# **FINAL ENVIRONMENTAL IMPACT STATEMENT FOR THE CANANDAIGUA LAKEFRONT PLANNED UNIT DEVELOPMENT**

**Prepared: May 13, 2010 (revised May 23, 2010)**

Figure 18A

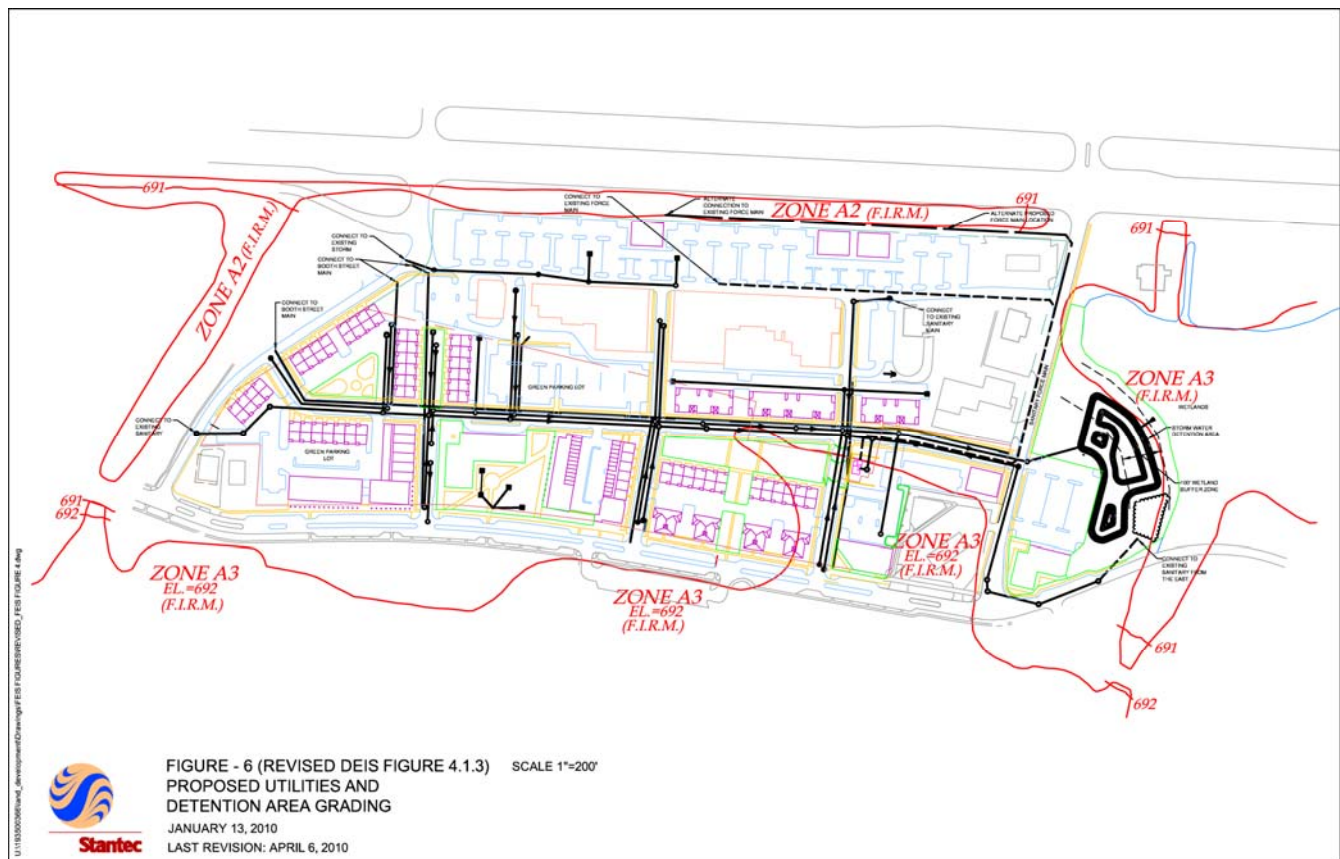
In a discussion of the proposed grading, there is a reference to Figure 4.1.3, but no figure is provided.

The EIS should discuss specific design criteria that will be necessary for the development of these stormwater facilities within the mapped floodplain such as berm heights and anti-backflow valves, etc. Also, the Department will need to review detailed stormwater plans to determine if a Dam Safety permit will be required.

Figure 4.13 was included in the DEIS Appendix and has subsequently been acknowledged by the Commenter. Figure 18A, shown below (this figure, identical with Figure 6 included earlier in this document, is a revised version of Figure 4.13 of the DEIS), highlights the proposed grading in the area of the detention pond.

The Applicant notes that the eastern stormwater detention area will not be located within the FEMA mapped floodplain; therefore, the incorporation of floodplain design criteria is not needed (*see* FEIS Figure 18A on pg.32). The Applicant anticipates that stormwater berms will only pond between 2 and 4 feet of water. Dam safety permits are typically required only when the ponding elevation is 10 feet or higher. Therefore, a dam safety permit requirement is not applicable for these relatively short berms.

The Applicant has indicated that the preliminary contours for the stormwater area were shown in Figure 18A on pg. 32 (See Revised DEIS Figure 4.1.3). The need for a stormwater detention area on the eastern (lowest) portion of the Project site is common to any of the development alternatives. The stormwater report (included in the DEIS) describes the proposed components including a fore-bay, sediment traps and wetland type vegetation.

Approximate contours for the stormwater facility are shown in Figure 18A on pg.32 of this FEIS. Section 3.4 also discusses potential construction in the wetland buffer area.

**Figure 18B**

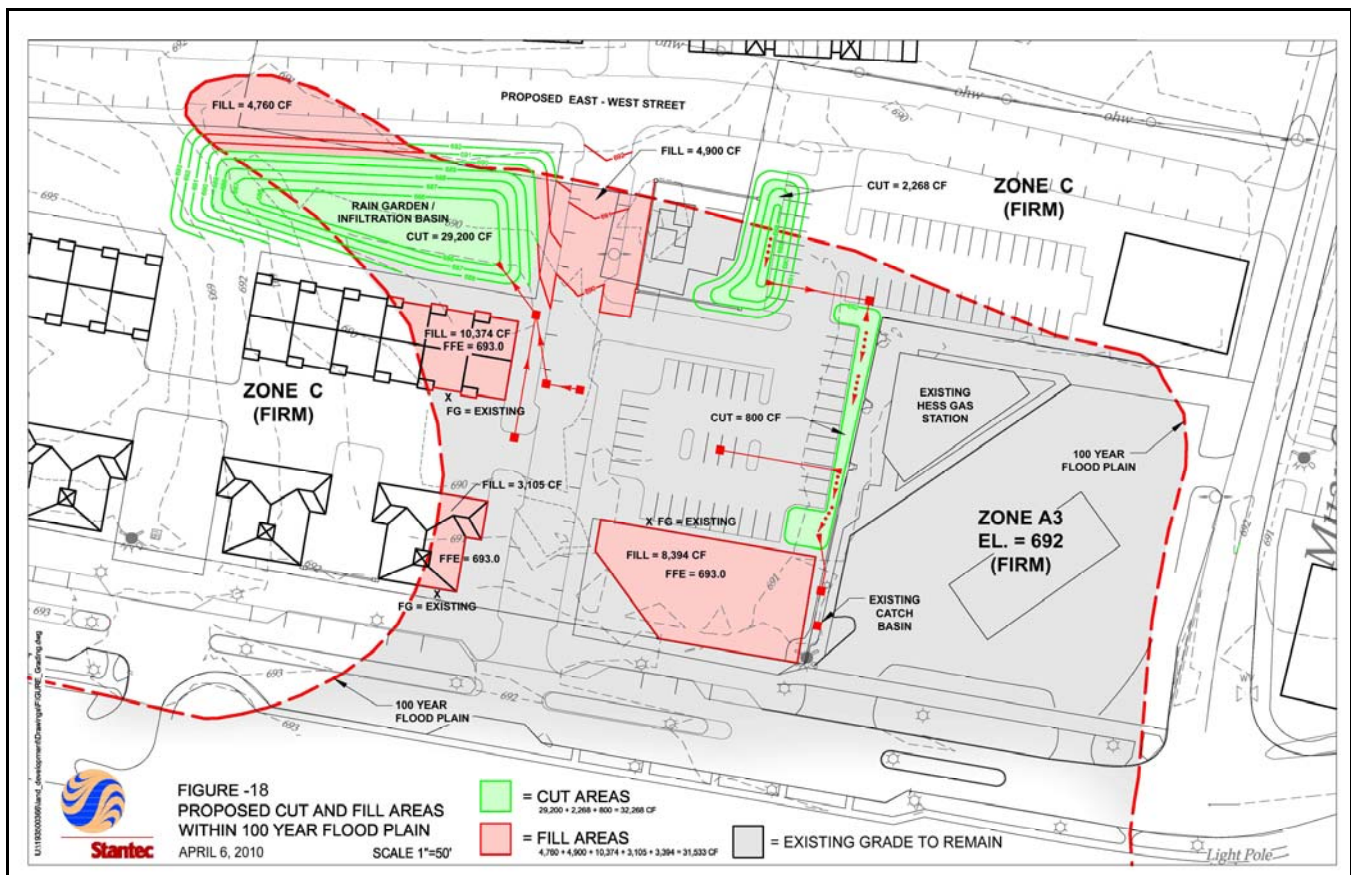
The proposed plan indicates the construction of more than 20 residential units in the 100-year floodplain. This is not permitted by local law.

However, in the event that no filling is allowed, Figure 18B below depicts an alternative approach to proposed cut and fill within the portion of the 100 year floodplain that is within the Project limits. Figure 18B shows that a cut/fill balance can be obtained during the design phase. Achieving this balance would eliminate any net increase of fill within the floodplain and, consequently, any impact or change to the base flood elevation. The downside to this alternative approach would include the necessity to use a portion of one designated green area as a "rain garden" and the inability to direct surface water runoff from within the limits of the floodplain to the stormwater management facility proposed for development just to the east.

As was described in the response to Comment 1 and illustrated in the associated Figure 18, should no filling be allowed, an alternate approach to grading within the area could be relied upon to ensure that there would be no net increase in fill within the flood plain. Although this approach would comply with the strictest application of both the City of Canandaigua and NYSDEC floodplain requirements, it would necessitate using a portion of one green area as a “rain garden” and would preclude discharging surface water runoff from within the floodplain area to the stormwater management area proposed for development to the east. The applicant has affirmed their belief that the Project remains feasible and that there is sufficient flexibility to ensure conformance with the applicable floodplain regulations.

Figure 22

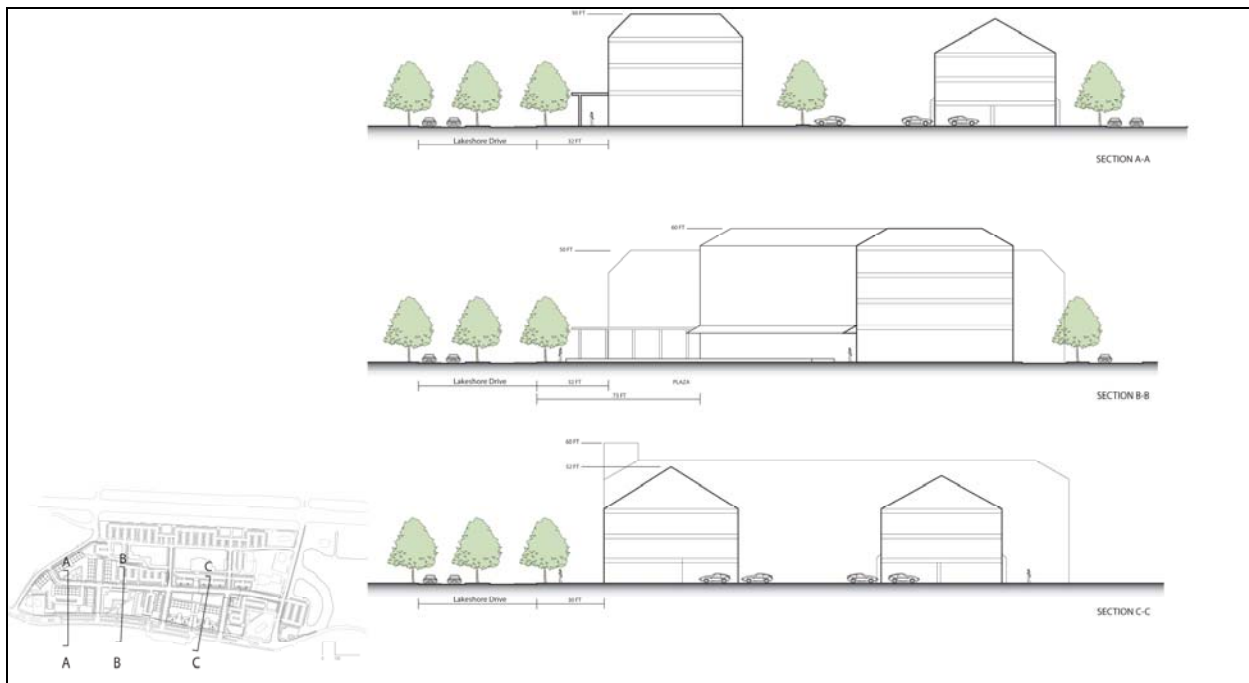
The proposed placement of buildings along Lakeshore Drive creates spaces (interruptions) between buildings that are uncharacteristic of urban streetscapes. The building spacing as shown in Figure 5.8.1 reflects more of a “campus” arrangement typical of suburban office parks and apartment complexes where the buildings stand separate from one another. More characteristic of urban streetscapes is building placement that creates a “streetwall” where interruptions from vacant space, parking lots and curb cuts are minimized.

Given that Lakeshore Drive will be framed on the north side by buildings and retail oriented open spaces, and on the south side by the grand vista of Canandaigua Lake, the Applicant believes that the placement of the buildings on the Lakeshore Drive frontage is critical. It is for this reason that a balance of setbacks and street framing is proposed. Figure 22 below shows some representative setbacks. The proposed minimum setbacks in the PUD are 0 feet for mixed use buildings (buildings characterized as being pulled forward) and 10 feet for residential buildings (buildings characterized as carefully setback).

Figure 22 above also shows proposed cross sections along Lakeshore Drive.

Figure 22 (included above in a preceding response) presents cross sections to scale with Lakeshore Drive and the sidewalk. The sections show that there are eight buildings proposed with zero setbacks. A simulated view from Canandaigua Lake looking toward the Project (Figure 16, which is revised Figure 4.5.2.B.6 of the DEIS), demonstrates that Alternative G will not overwhelm the lakefront district. Figure 3 shows that more open space is being provided in Alternative G than what was proposed in the previous sketch plan.
